CITY OF CODY
PLANNING, ZONING, AND ADJUSTMENT BOARD
TUESDAY, JANUARY 22, 2019
CITY HALL COUNCIL CHAMBERS @ 12:00 NOON

MEETING DATE:	JANUARY 22, 2018	TYPE OF ACTION NEEDED	
AGENDA ITEM:		P&Z BOARD APPROVAL:	X
SUBJECT:	SITE PLAN REVIEW: WASTEWATER TREATMENT FACILITY PHASE 2 UPGRADES. SPR 2018-26	RECOMMENDATION TO COUNCIL:	
PREPARED BY:	TODD STOWELL, CITY PLANNER	DISCUSSION ONLY:

MEETING DATE:	JANUARY 22, 2019	TYPE OF ACTION NEEDED	
AGENDA ITEM:		P&Z BOARD APPROVAL:	X
SUBJECT:	SITE PLAN REVIEW: HAMPTON INN AND SUITES. SPR 2018-24	RECOMMENDATION TO COUNCIL:	
PREPARED BY:	TODD STOWELL, CITY PLANNER	DISCUSSION ONLY:

Plan View
Scale - 1" = 20ft

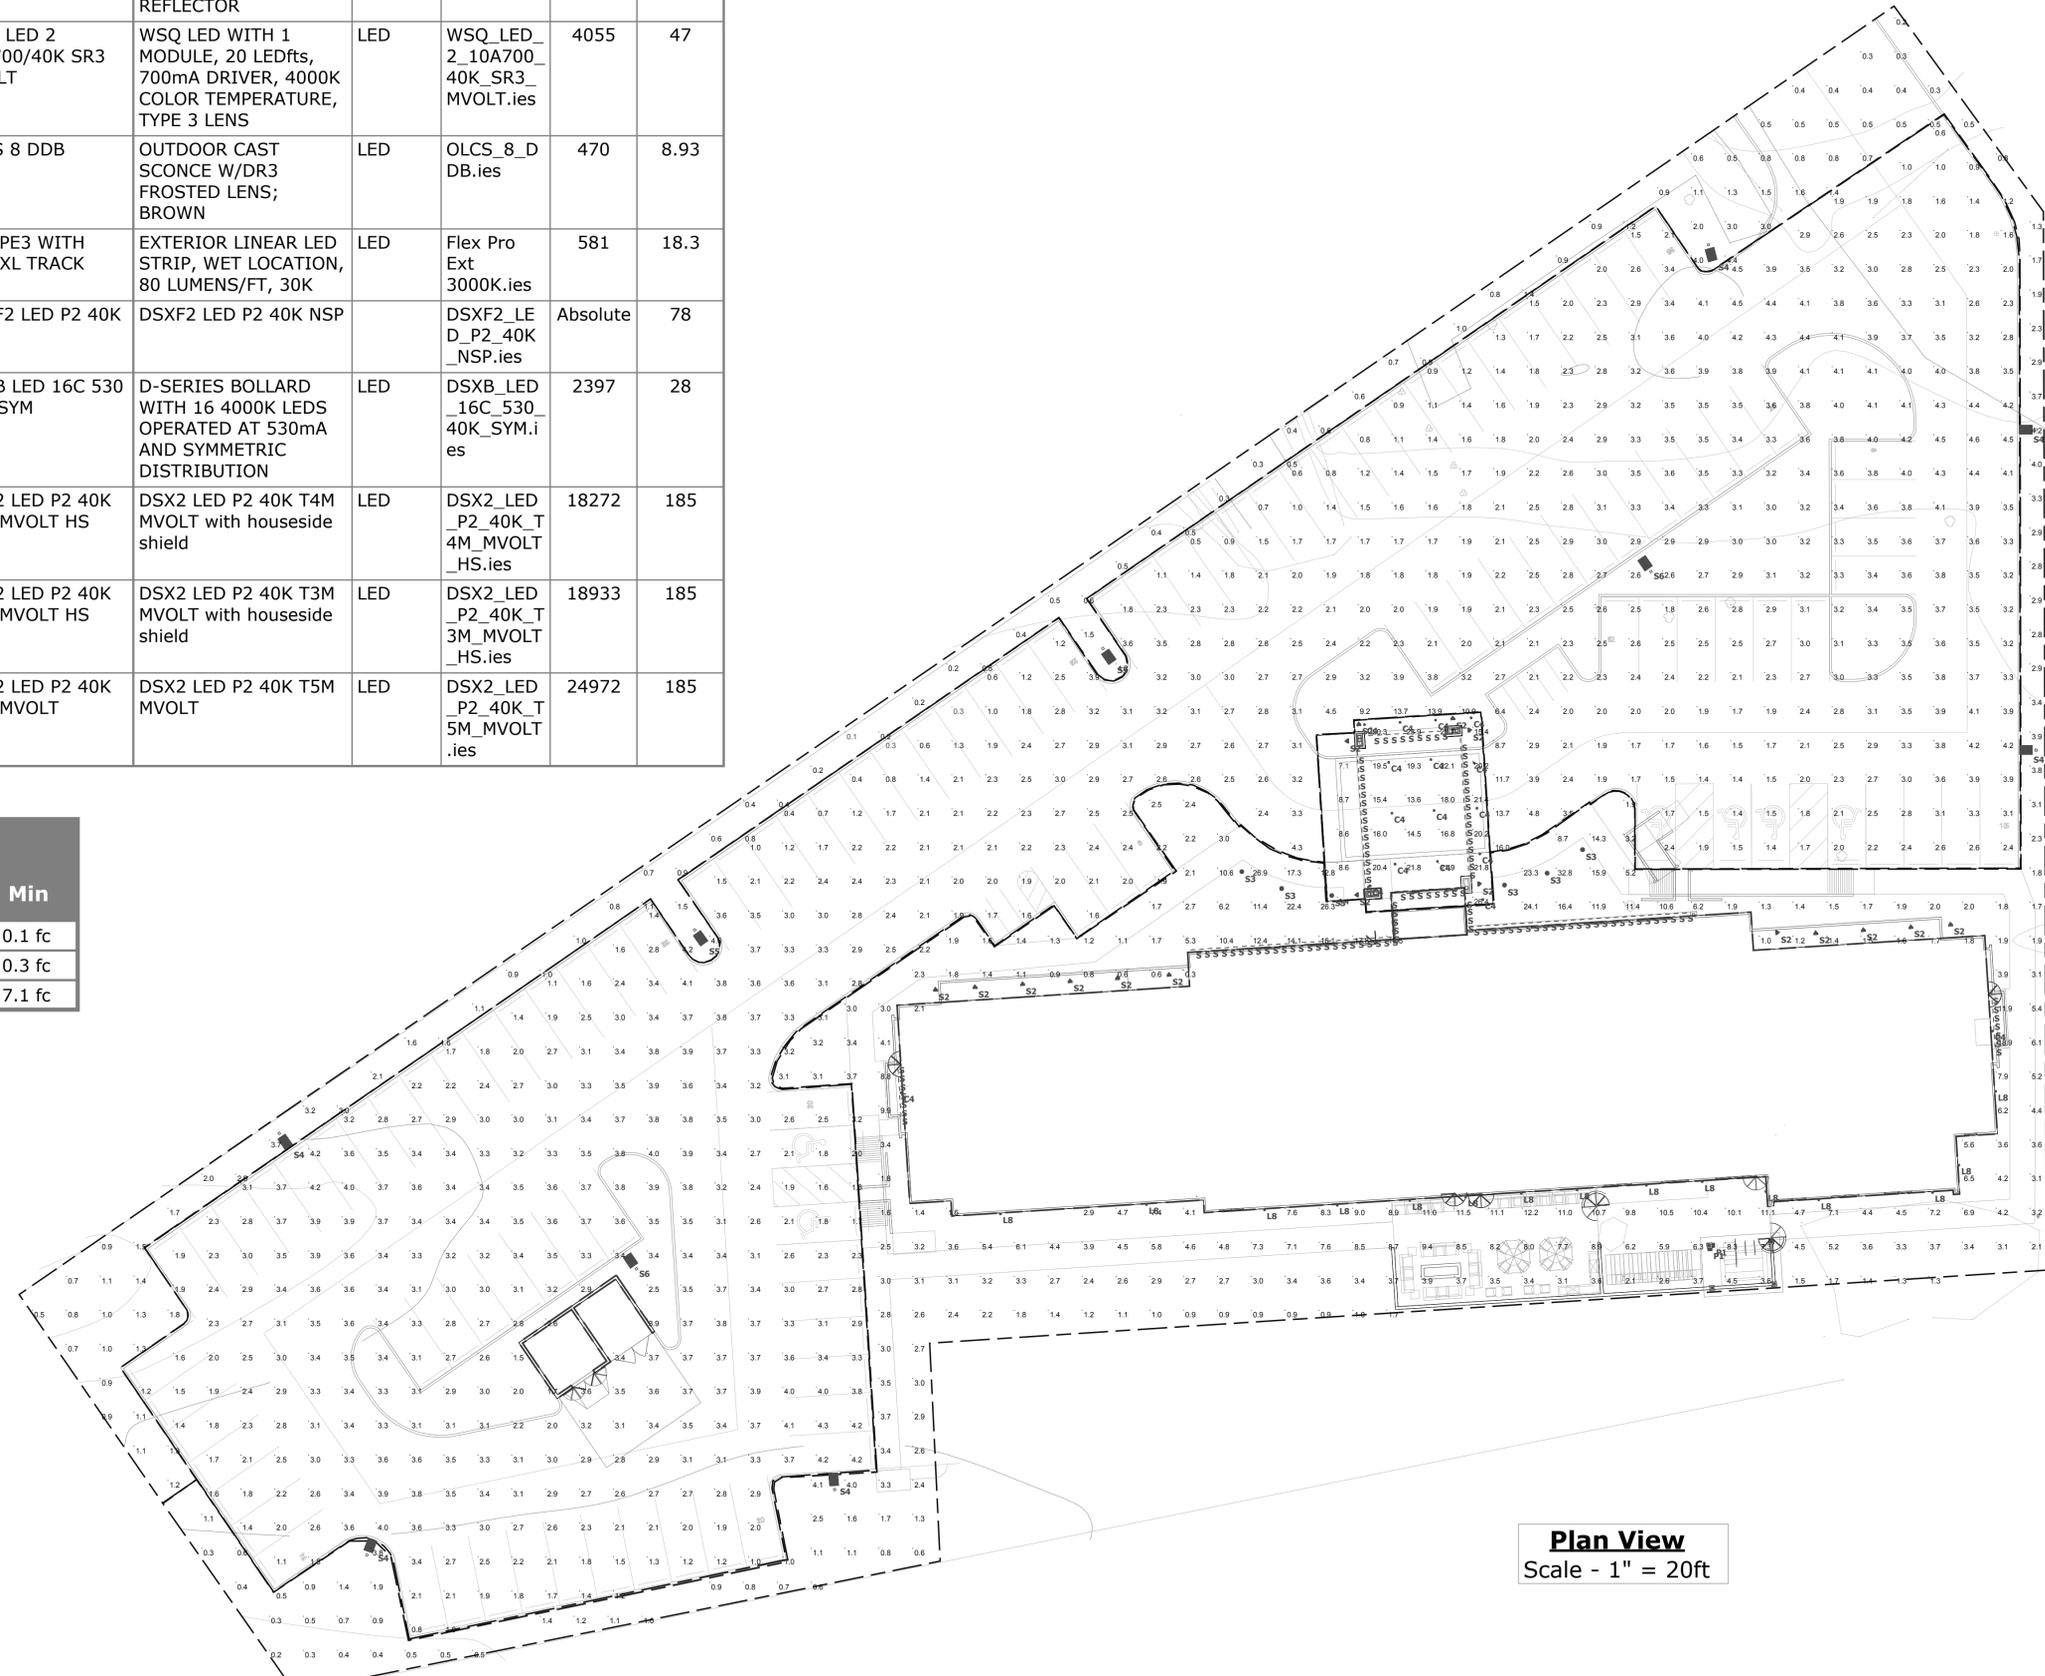
The overall lighting plan definitely illuminates the project, but does not result in excessive light spillage beyond the property lines, other than the immediate area of the two lights along the east side. However, with the revised parking lot layout, those lights will likely be shifted a few feet away from the line than where originally planned.

15. Identify the height of the parking lot light poles on the plans (25').
16. Add a note on the site plan about installation of the irrigation distribution conduits and electrical conduits prior to construction of the parking lot facilities.
